Incomplete Application Response

25-105629-PLN | 4900 Block of 27th Avenue SE

This letter shall serve as the applicant's response to an incomplete application notice received on April 9th, 2025. This response is organized by item in the same order as the incomplete letter.

D REAR (NORTH) ELEVATION
SCALE: 1/8" = 1'-0"

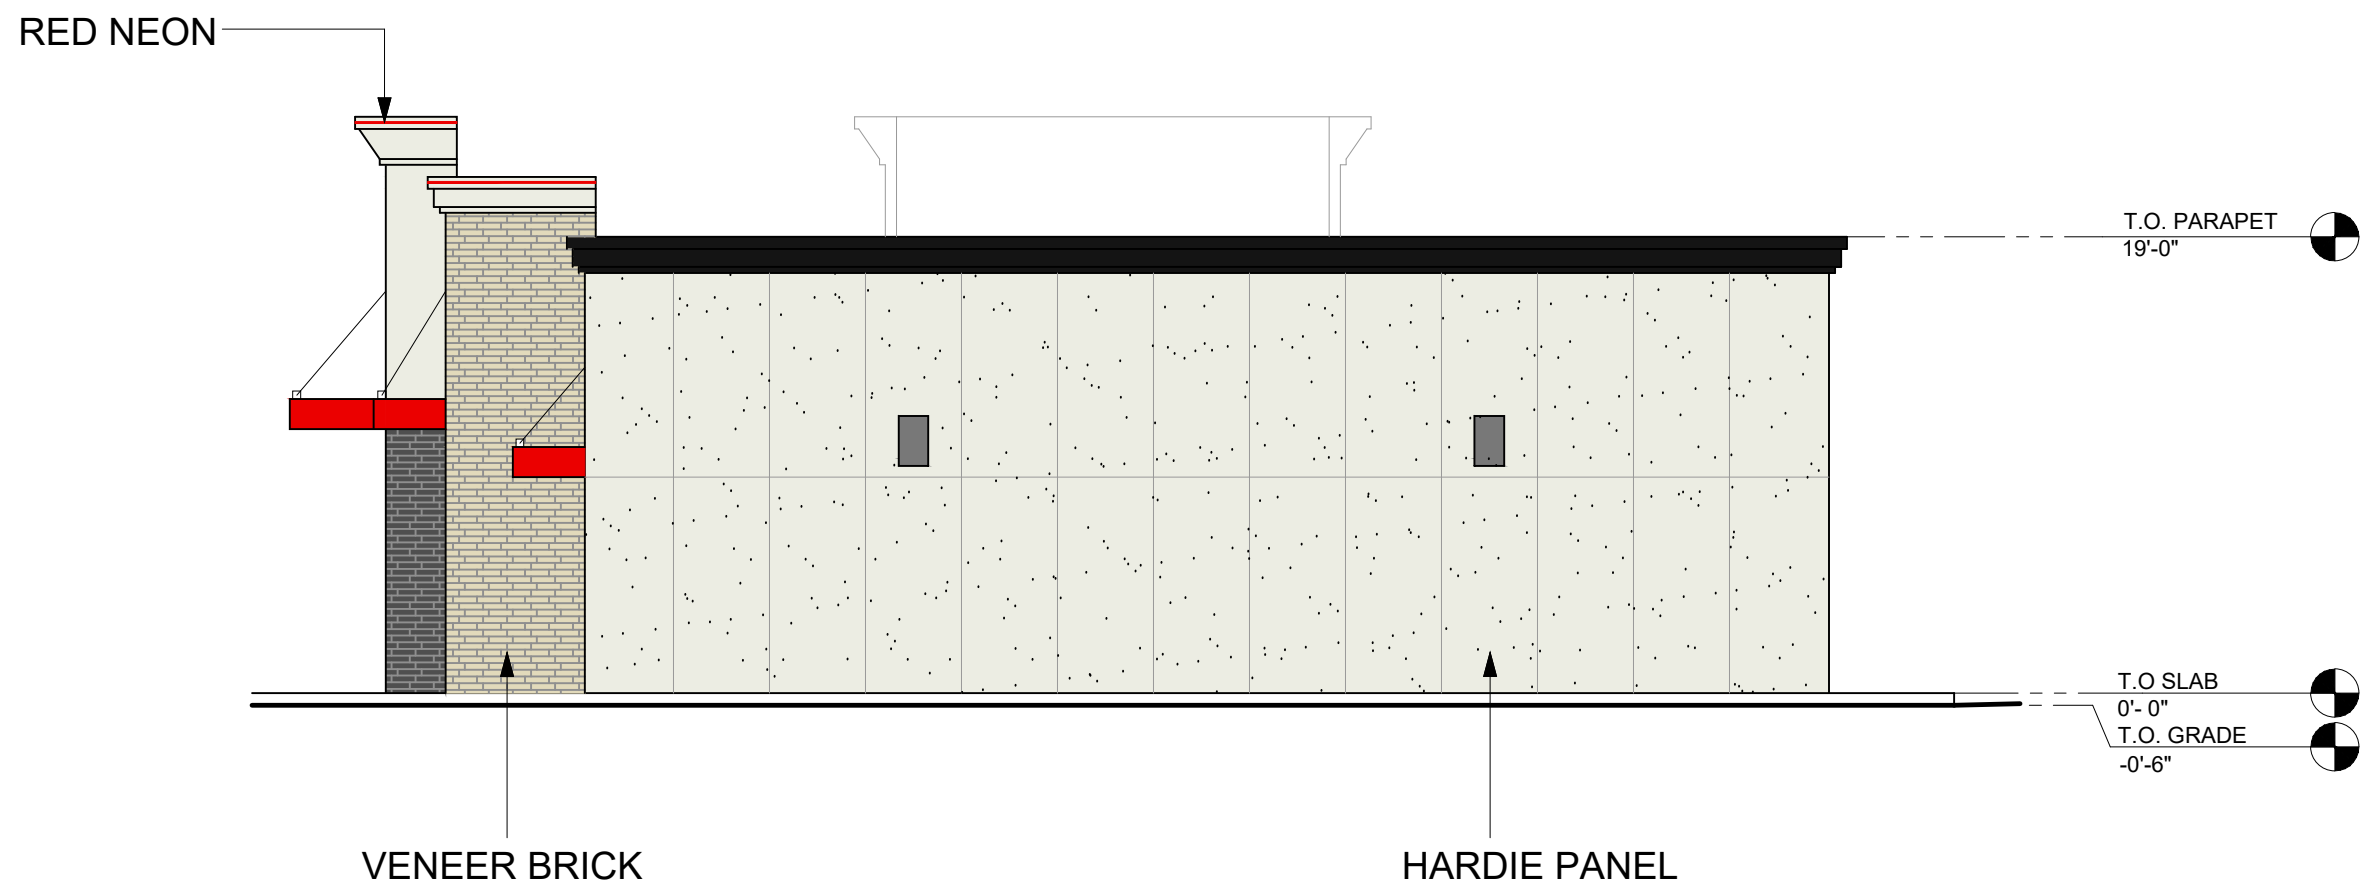
4. The applicant is requesting an adjustment to SRC 535.015(g)(5) to eliminate the requirement for ground-floor transparent windows along the north elevation, which faces Kuebler Boulevard. This standard is intended to create pedestrian-oriented street frontages by requiring windows that provide visibility into the building, enhance safety, and promote active architectural design. In this case, the proposed development equally meets the purpose of the standard through site-specific conditions and enhanced design features that render transparent windows along the north elevation functionally unnecessary and visually redundant.

The building's north elevation does not function as a primary façade, and no pedestrian access or public entrances are provided along this side. The elevation is located approximately 95.5 feet from the public sidewalk along Kuebler Boulevard and is separated from the street by a 6-foot elevation change. Additionally, mature vegetation and trees associated with the adjacent creek corridor further screen the building from public view. These topographic and vegetative buffers significantly diminish the visual prominence of the north façade, thereby reducing the relevance of the window requirement in achieving pedestrian activation or street-level transparency. Although no windows are proposed on this elevation, the project architect has incorporated high-quality design treatments to ensure the building remains visually interesting. The revised elevation includes a mix of materials, including dark gray Hardie plank paneling designed to mimic the scale and appearance of window openings. These elements provide architectural articulation and rhythm, preventing the façade from appearing blank or monotonous. The result is a visually appealing and cohesive elevation that aligns with the character of nearby development at the intersection of Kuebler Boulevard and Battle Creek Road.

Given the significant physical separation, natural screening, lack of pedestrian activity along this frontage, and the enhanced architectural detailing applied to the façade, the purpose of SRC 535.015(g)(5) is equally met. The requested adjustment allows for site-sensitive design while still supporting the broader goals of visual interest, architectural quality, and compatibility with the surrounding area. Accordingly, the applicant has demonstrated that the proposed design satisfies the adjustment approval criterion under SRC 250.005(d)(2)(B)(ii).

To enhance visual interest and meet the intent of the standard through architectural quality, the project architect has revised the elevation drawings for the north façade to incorporate dark gray Hardie plank paneling, which mimics window paneling and provides the appearance of fenestration. Additional material changes and architectural detailing have been added to the elevation to ensure it avoids blank walls and contributes to an attractive streetscape, even if partially obscured by distance and vegetation. Given the substantial separation from the public sidewalk, limited visibility, significant grade change, and enhanced architectural treatment, the north façade cannot function as a practical location for a primary entrance. The applicant's revised site design and building orientation still promote pedestrian access and façade articulation consistent with the purpose of SRC 535.015(g)(4). Therefore, the request satisfies the adjustment approval criterion under SRC 250.005(d)(2)(B)(ii) because the purpose of the standard is equally met.

B LEFT SIDE (WEST) ELEVATION
SCALE: 1/8" = 1'-0"

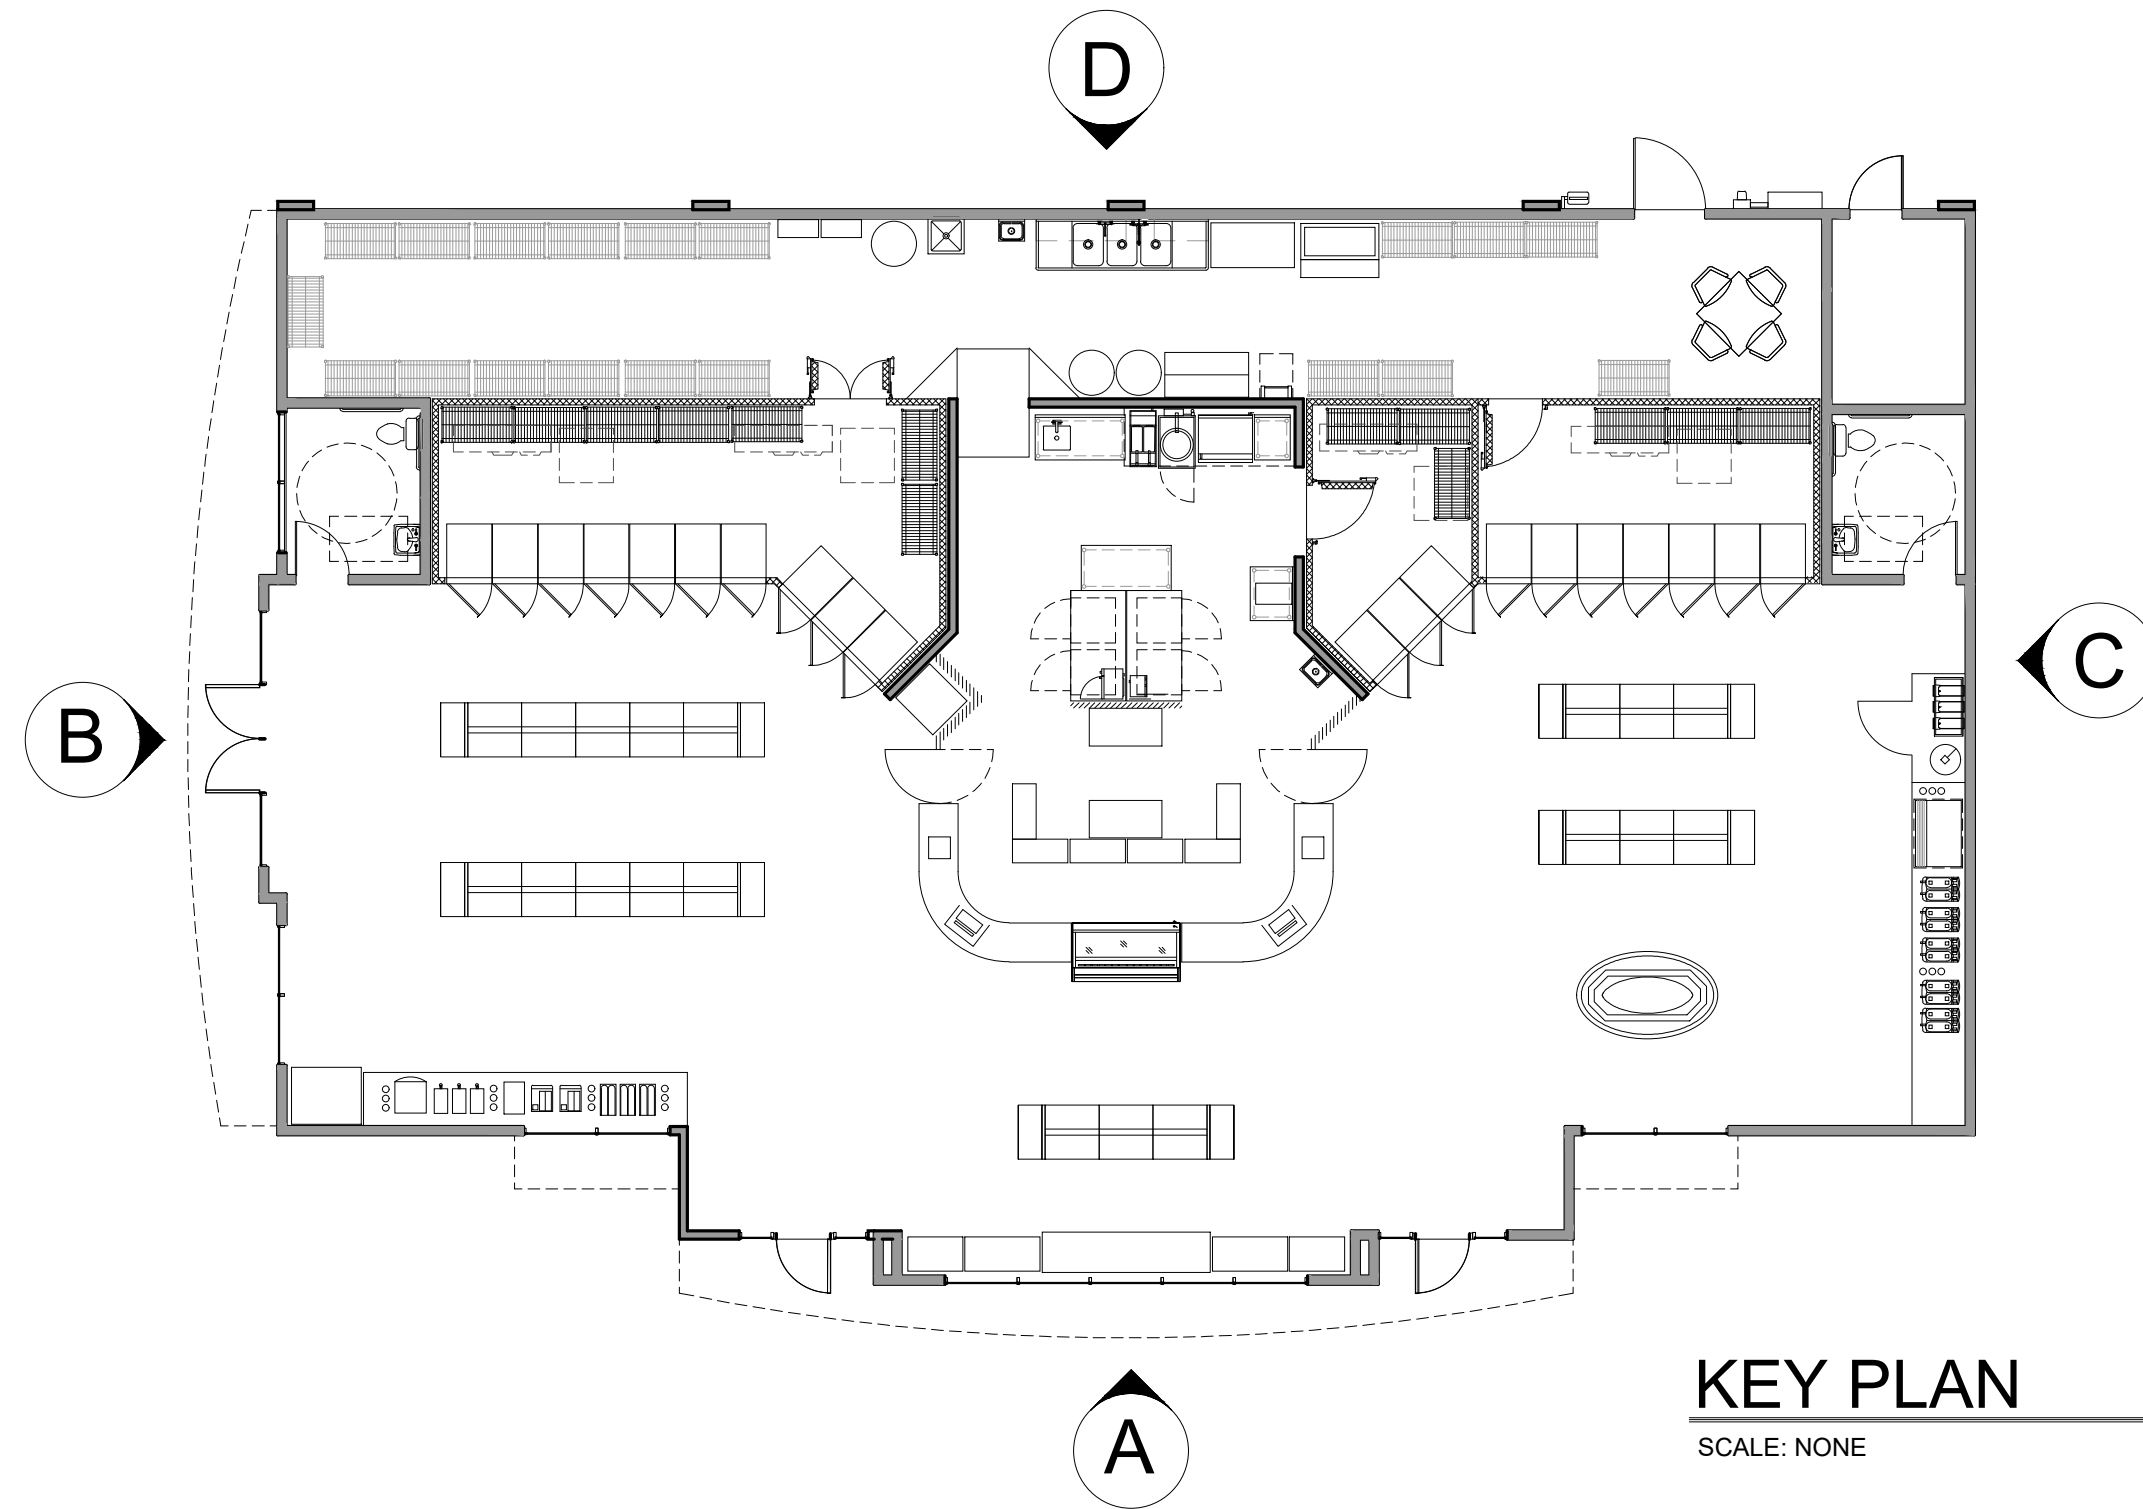
3. The applicant is requesting an adjustment to SRC 535.015(g)(5), which requires ground floor façades within the maximum setback and facing a street to include transparent windows on at least 50 percent of the façade. The standard further requires that those windows not be mirrored or treated to block visibility into the building and that they have a minimum visible transmittance (VT) of 37 percent. The building's west elevation fronts 27th Avenue and is located within the maximum setback. The project architect has revised the elevation to provide ground floor windows across 55.86 percent of the façade, using the measurement methodology allowed under SRC Chapter 111. This exceeds the minimum percentage requirement, and the windows are strategically located to maintain architectural rhythm and visual interest.

However, the applicant is requesting an adjustment specifically to the VT requirement of SRC 535.015(g)(5), because one of the windows along this elevation will be a faux window that does not permit visibility into the building and therefore does not meet the required VT minimum. The faux window is placed in a section of the building used for back-of-house operations where interior visibility is not functionally feasible. Despite not meeting the literal transmittance requirement, the faux window mimics the scale, proportion, and appearance of a true transparent window, thereby preserving the visual continuity of the façade and supporting the pedestrian-oriented design intent of the standard.

The project architect has revised the west elevation, which faces 27th Avenue and is within the maximum setback, to more closely comply with the standard. The updated design includes a series of transparent windows and one faux window to maintain visual rhythm and architectural consistency. The faux window is located in a "back-of-house" area where interior operations do not support visibility into the building due to functional constraints. However, the faux window mimics the appearance of a true window in size, proportion, and placement, contributing to an active and articulated streetscape. Using the alternative ground floor measurement methodology permitted under SRC Chapter 111, the revised west elevation provides 55.86 percent window coverage, exceeding the minimum 50 percent threshold. This demonstrates clear compliance with the standard's intent, while allowing a minor flexibility in treatment to accommodate the building's interior

The remaining windows on the west elevation are transparent and contribute to the building's engagement with the street. Together, the window design creates an articulated, human-scaled façade that avoids blank walls and supports an active streetscape. By achieving the required window coverage, reinforcing rhythm and architectural detailing, and including a limited faux window only where interior function requires it, the proposal meets the purpose of the ground-floor window standard, even though one window does not meet the specific VT requirement. Therefore, the adjustment satisfies SRC 250.005(d)(2)(B)(ii) because the overall design equally meets the intent of the standard—to provide transparency, interest, and pedestrian-scale design on street-facing façades.

PRELIMINARY LANDSCAPE PLAN

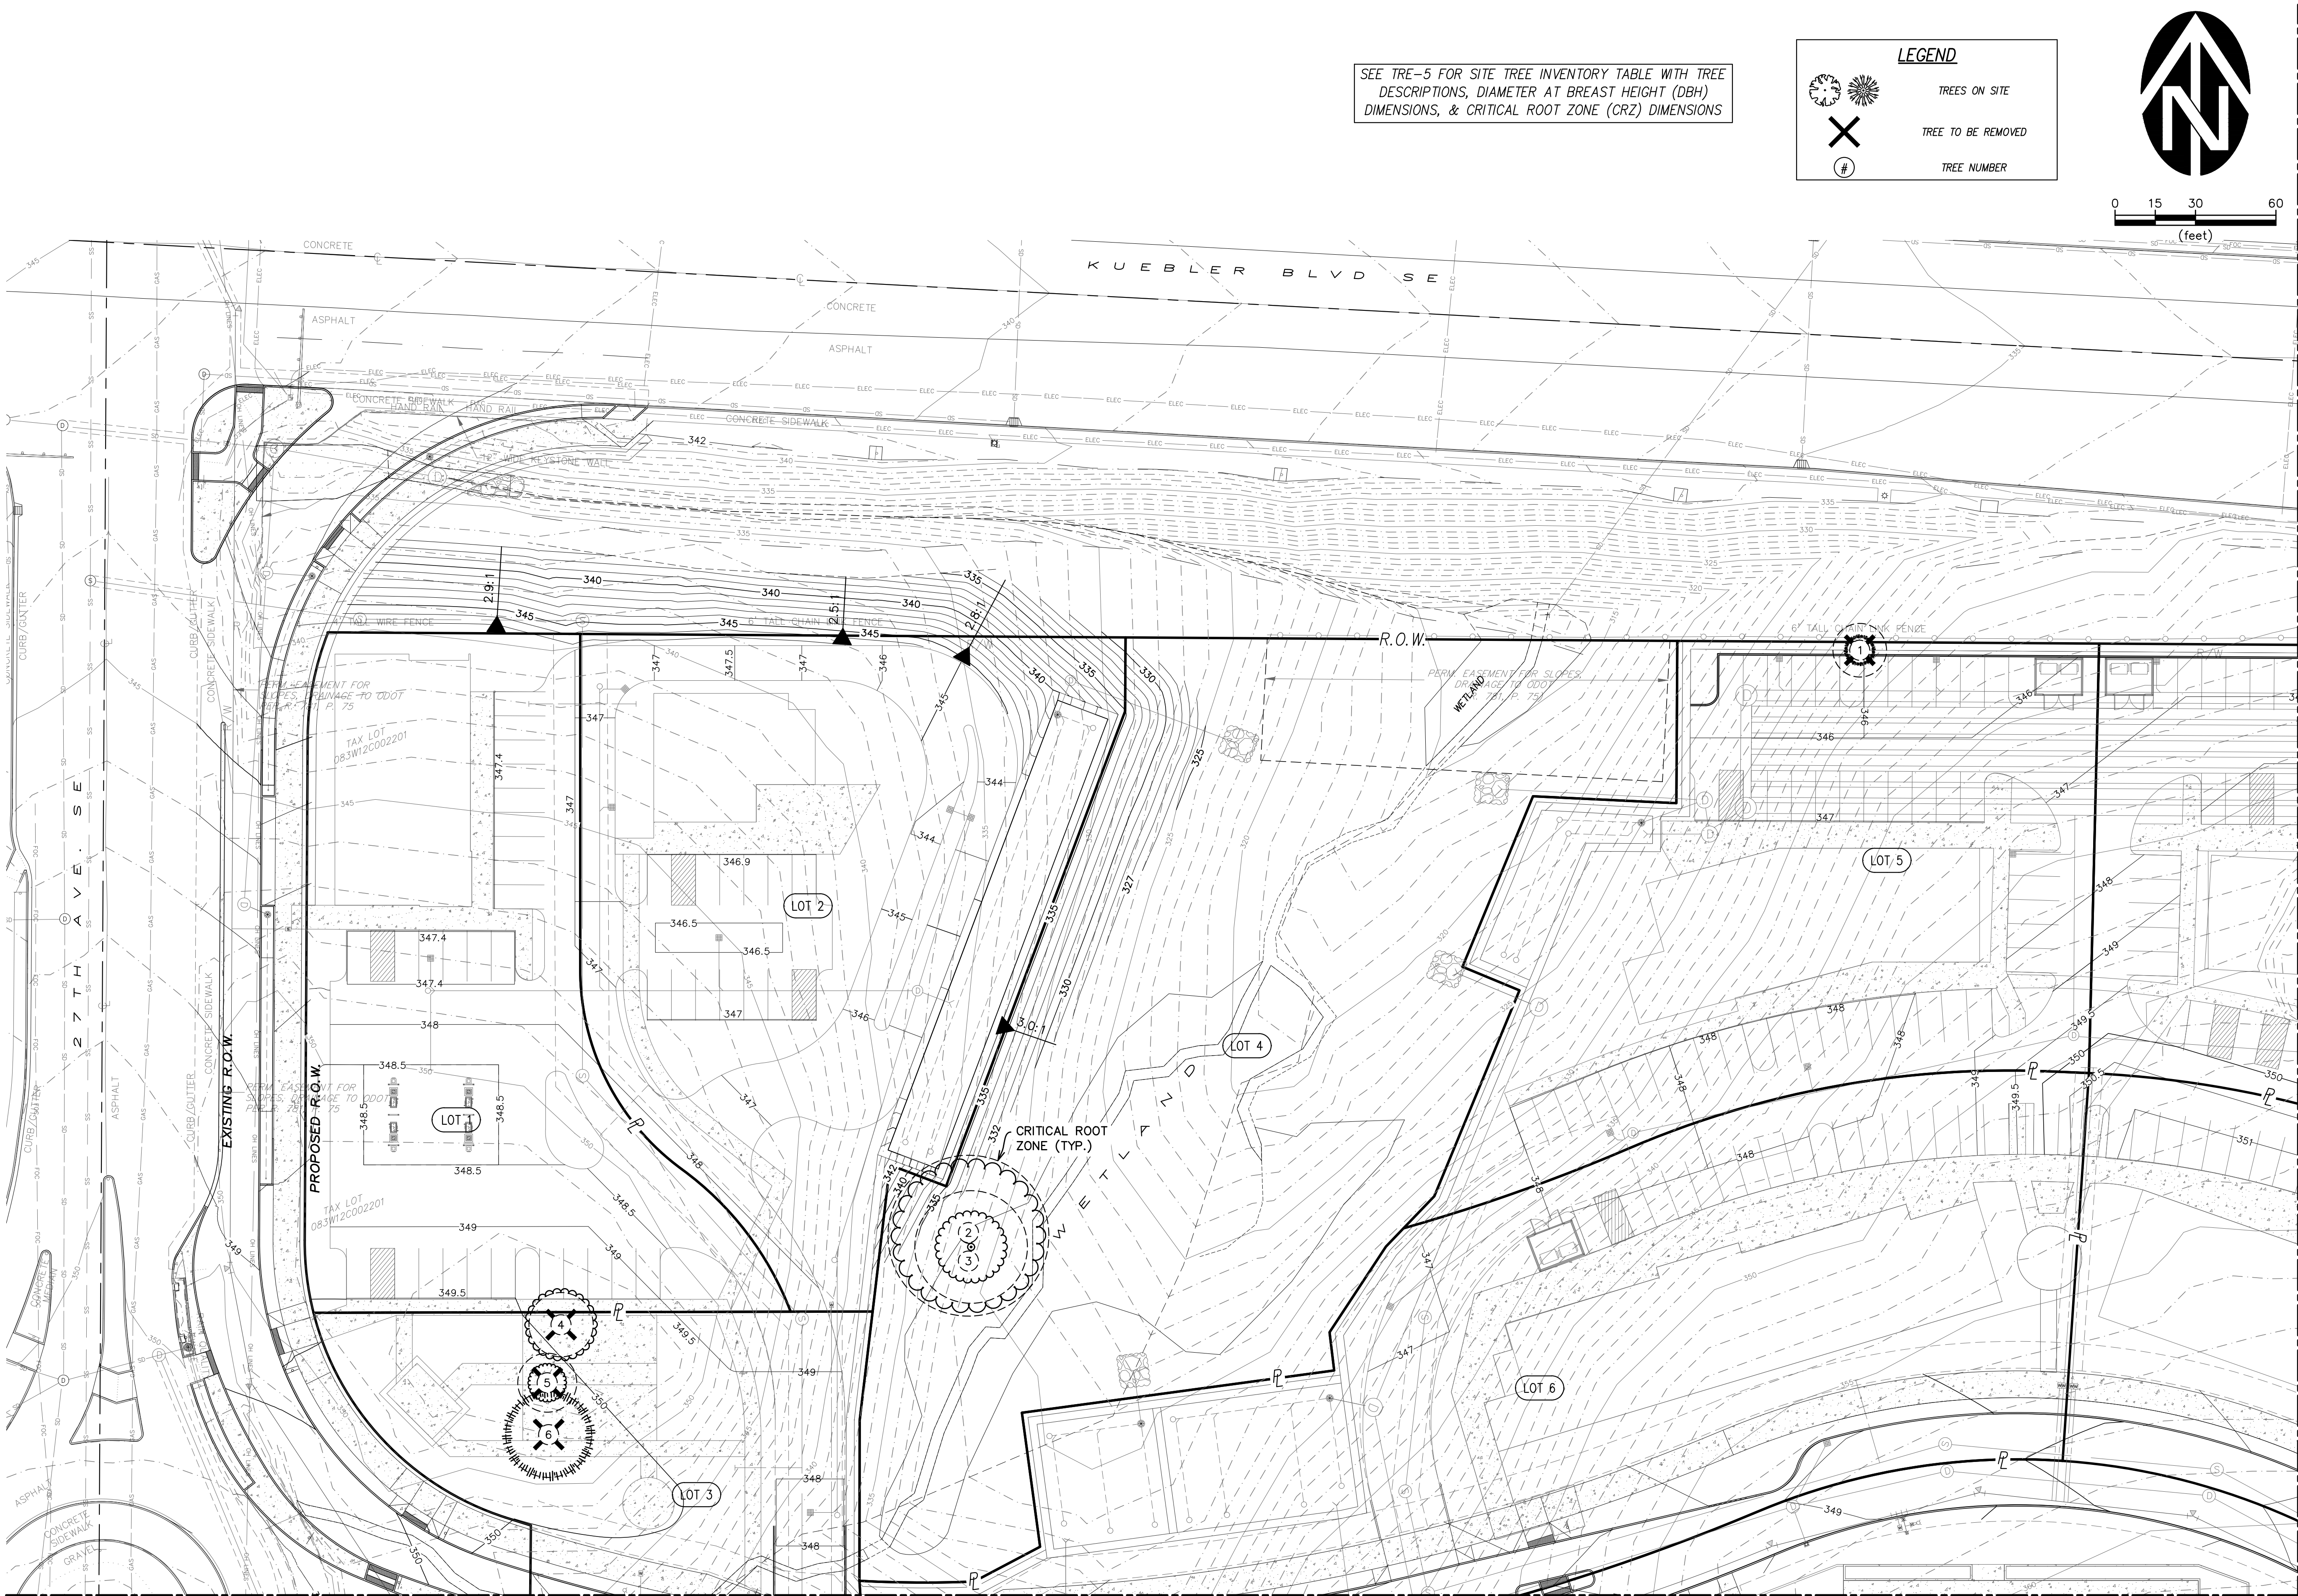
Item 12: Interior Parking Landscape

Applicant's Response: Both the original and revised site plans provided by the project architect include a table outlining the development standards and

project calculations. The plans demonstrate adequate interior landscaping is provided. In accordance with the table, the off-street parking areas total 12,087 square feet in size and triggers a minimum of 5 percent landscaping, or a total of 604 square feet. The site provides 1,469 square feet of interior landscaping, which is more than double the required minimum. This item is resolved.
